## Contaminated Land Internal Memorandum of Technical Advice

To:	Development Management	From:	Head of Public Protection & Prevention
Planning Officer:	Vivienne Pearson	EP Officer:	James Warren-King
Flare Ref:	249483	Date:	14 June 2023
Planning Ref:	2023/00339/DISCON	Doc Ref:	23-06-14-T265-M02-JWK-WBCDC

**SUBJECT: CONTAMINATED LAND DOCUMENT REVIEW:**

8 HILL CLIFFE ROAD, WALTON, WARRINGTON, WA4 6NX.

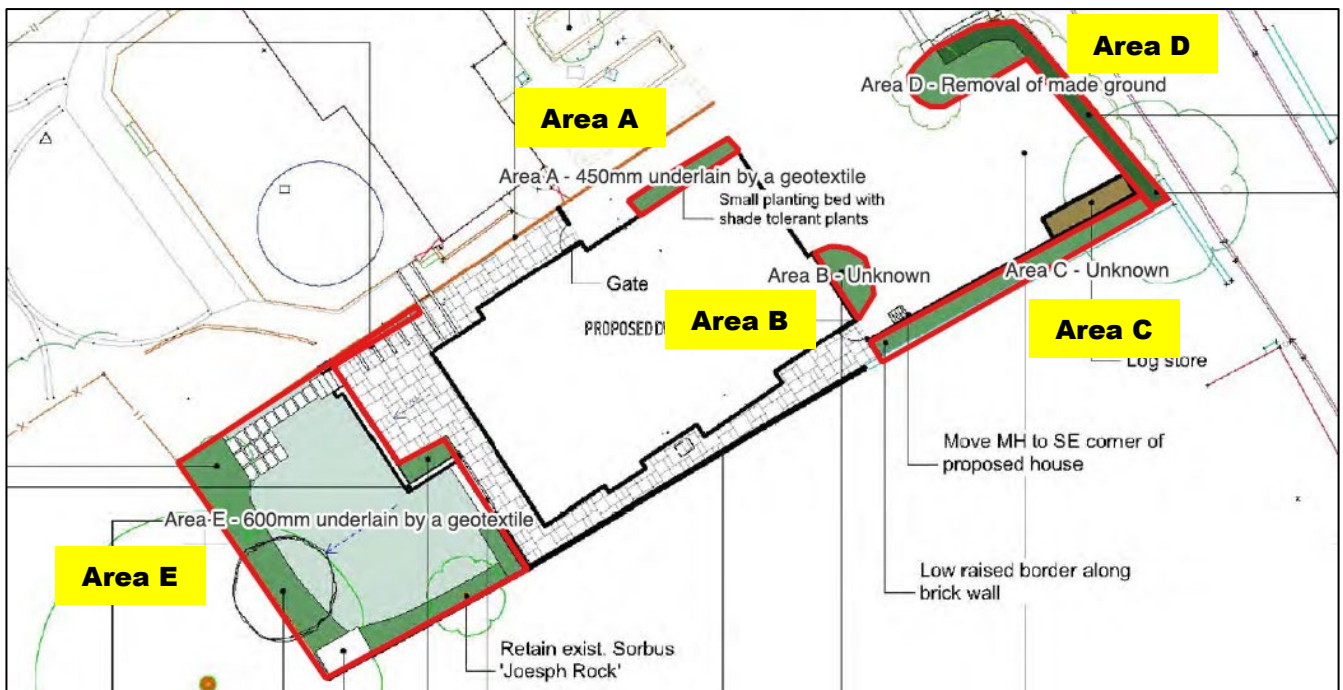
- **Source-removal of Contamination:** Reporting (DEL, 2023<sup>2</sup>) confirms that up to 500mm of Made Ground will be excavated and removed from Area D and potentially Areas B and C as well. These areas are proposed for soft-landscaping as shown on the plan below:

- **Cover Systems for Gardens & Soft-landscaping:** Reporting (DEL, 2023<sup>2</sup>) confirms that all areas proposed for gardens (Area E) will receive a 600mm cover system formed of site-won/imported fill materials. All areas proposed for Soft-landscaping (Areas A, B and C) will receive a 450mm cover system formed of site-won/imported fill materials. A Geotextile separator is to be placed at the base of the cover system. Area D is not to receive a cover system after the source-removal of Made Ground.
- **Other Remediation:** No other remediation is proposed for the site or the development scheme.

The Remediation Strategy is deemed **satisfactory** and appropriate for a site of this nature and the proposed development works.
